Preferred Project Report Broadway Building

University of Technology Sydney
Project Application No. 09_0212

Submitted to the Department of Planning & Infrastructure
On Behalf of the University of Technology Sydney

October 2011 ■ 10092

Figure 1 - Section of Colonnade along Broadway (Source: DCM)

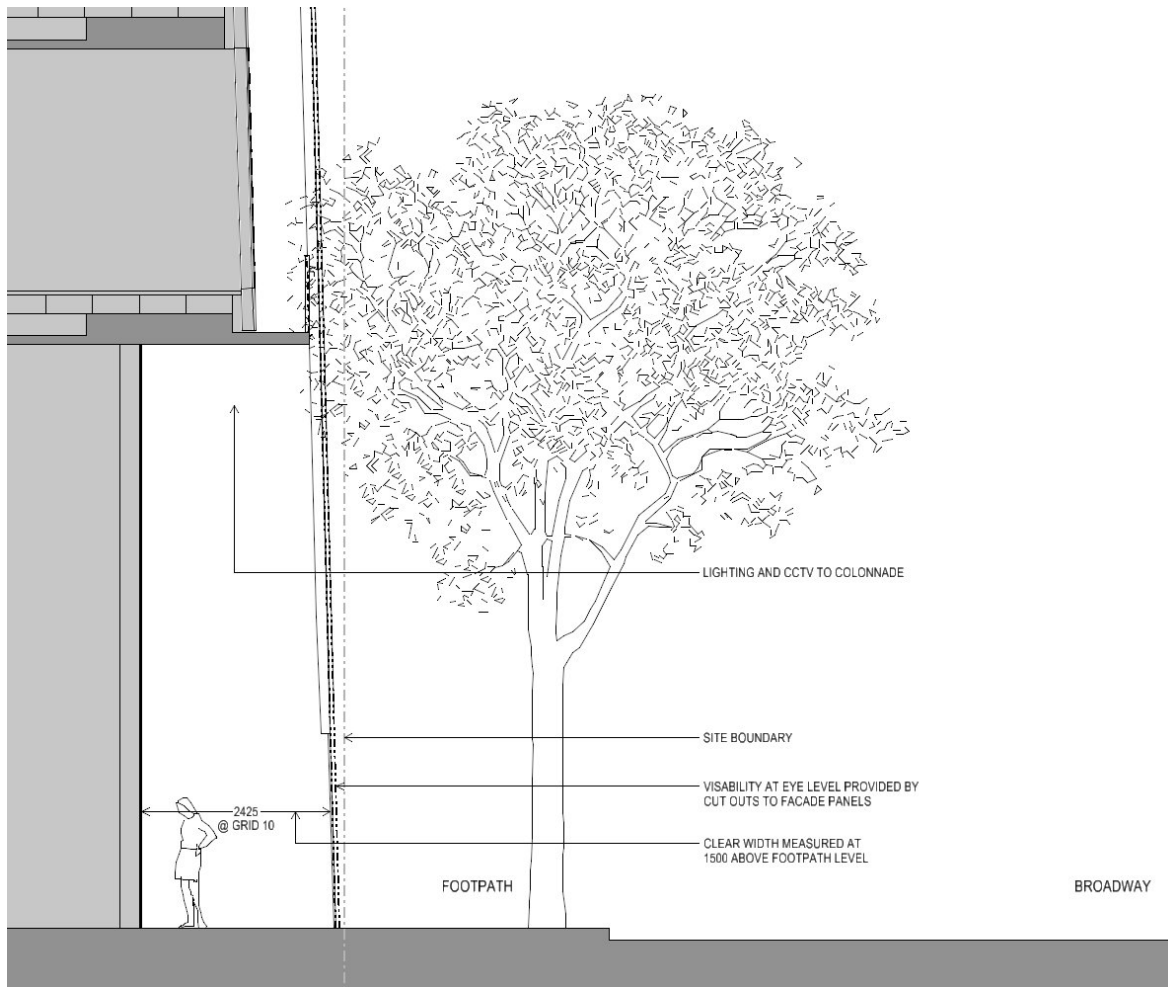
The City of Sydney, in its submission, raised concerns about the adequacy of weather protection in the undercroft between the screen and the building along Broadway and impacts on pedestrian amenity. The matter was further discussed in a meeting between the University and City officials (Graham Jahn and others, 16 June 2011) where a width of 2.5 to 3 metres for the undercroft was suggested.

In response to the issues raised by the City of Sydney, the proponent has increased the width of the undercroft by moving the southern glass facade of the building inwards at street level. This also required moving the columns behind. The new arrangement creates a covered walkway within the property boundary of a minimum width of 2.4 metres (see **Figures 1 & 2** and **Attachment 3**). Due to the skewed facade plate, the walkway widens to about 2.6 metres towards Wattle Street.

Any further adjustment of the glass facade (to achieve a 3 metre wide walkway) would have significantly compromised the structural components of the building.

This adjustment is considered adequate and suitable to meet the City's requirements given that two other weather protected routes supplement the Broadway footpath - the diagonal path through the Broadway Building and the covered Arcade on the northern side of the building.

Figure 3 - Anti-climb zone (Source: DCM)

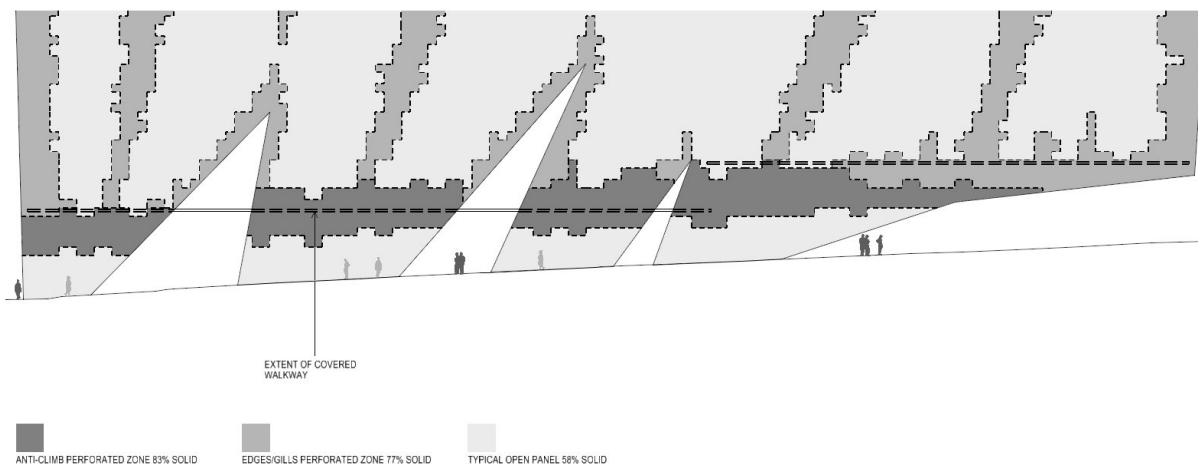
In addition to issues about the width of the colonnade, concerns were raised that the screen could provide a concealment hazard or be dangerous. The proponent's response to potential safety and security matters is described below.

In order to make the screen difficult to climb, the level of perforation is to be reduced and solid areas are to be increased in the 'anti-climb zone' which is approximately 3.0m to 6.5m above the street. In the non-climb zone the slots and cut outs will be filled in with a fine perforation, which increases the solid area from 58% to 83% (see **Figure 3**). Since the fine perforations in the anti climb zone extend below the height of the covered walkway, they also contribute to rain protection within the colonnade.

The perforations around the screen edges and gills areas will be 77% solid to support the screen's structural integrity and to withstand physical damage.

Figure 4 - Plan of Arcade (Source: DCM)

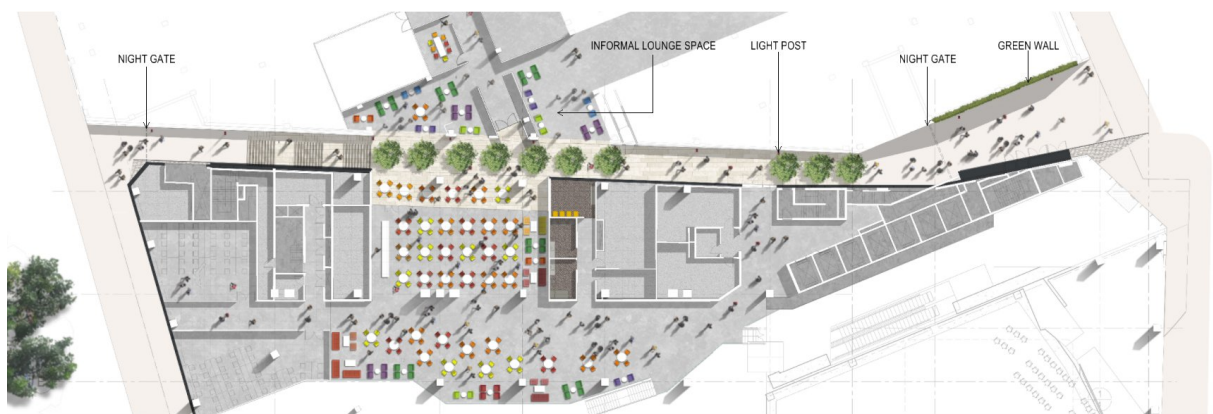
The landscape treatment of the Arcade has been significantly modified since the exhibition of the EAR in response to issues raised by the City of Sydney. A new Landscape Design Report, replacing that in the EAR, is appended to the PPR at **Attachment 7**.

The design of the Arcade has been further developed since the exhibition of the EAR (see **Figure 4**). The Arcade will provide a semi-enclosed circulation space protected from the elements by a glass roof above. In addition to its role as a circulation route, the Arcade will provide a social hub between the two buildings, linking the student union spaces in the Broadway Building via an open on-grade terrace to the student services and proposed informal teaching spaces within CB10.

As part of this project, a new on-grade entrance to CB10 is to be created via a new opening - approximately 3.5metres high and 3.5 metres wide - to the existing south facade of CB10 to connect activities across the Arcade between the Student Union in the Broadway Building and the student services area in CB10. Existing fixed windows and glass louvres on the CB10 facade will be removed and new glazed double doors will be installed to match the existing conditions (see Level 01 Floor Plan at **Attachment 1**).

Figure 7 - Image of screen and gills at night (Source: Electrolight)

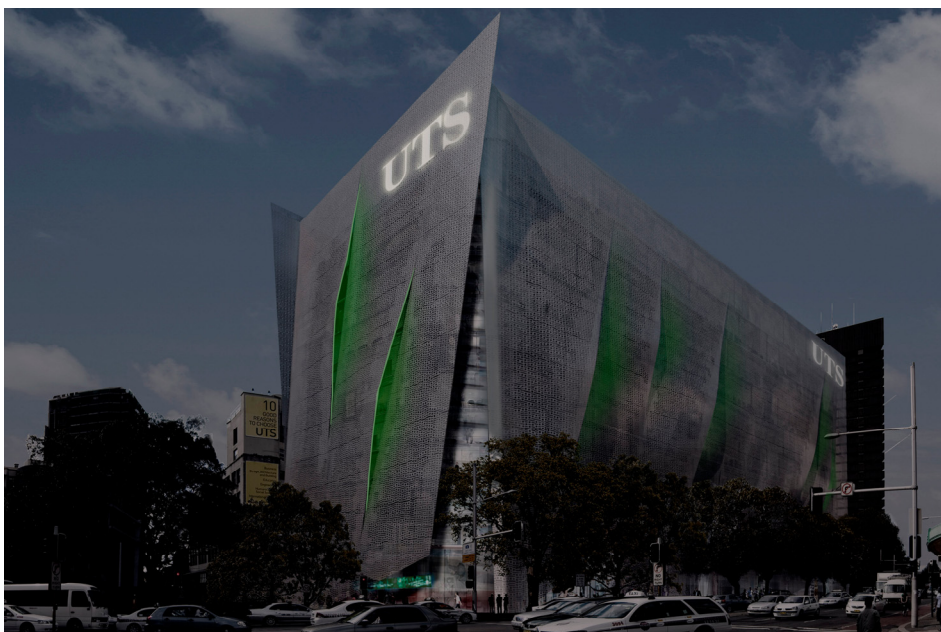
<p>Safety of space between the screen and the building</p> <p>The binary screen may provide a concealment hazard, especially when the building side is not illuminated. Measures should be implemented to provide passive surveillance at night, such as the provision of lighting within corridors.</p>	<p>Lighting and other measures have been incorporated into the design to facilitate surveillance of the space behind the screen, see Sections 3.2 and 3.4.</p>
<p>Weather protection</p> <p>CoS recommended that the external screen be adjusted to provide some weather protection along Broadway in order to improve pedestrian amenity, and that any awning treatment comply with Council's requirements. Alternatively, an independent lightweight weather protection awning should be provided to the satisfaction of the City of Sydney Council.</p>	<p>The colonnade has been enlarged to provide better protection, see Section 3.1.</p>

Instead of a uniform wash of light which risks flattening the textured nature of the façade and contributing to unwanted sky glow, it is proposed to contain the light of the southern, western and eastern facades to the 'gills' of the screen, as shown in **Figure 7**. These integrated highlights on the façades will allow the perimeter of the building to visually extend and merge without a defined edge or prescribed direction.

Custom lengths of 20mm diameter cold cathode tube will be mounted along the outer edge of the protruding gill. The effect will be to produce a subtle green glow, activating the gill's form and defining the leading edge with a visible linear source. To ensure the visual comfort of pedestrians, motorists and occupants of the building, the largest available diameter of cold cathode will be used to provide a diffused source with a relatively low surface brightness. The vertical mounting arrangement will provide light to the facade material without contributing excess light to the night sky.
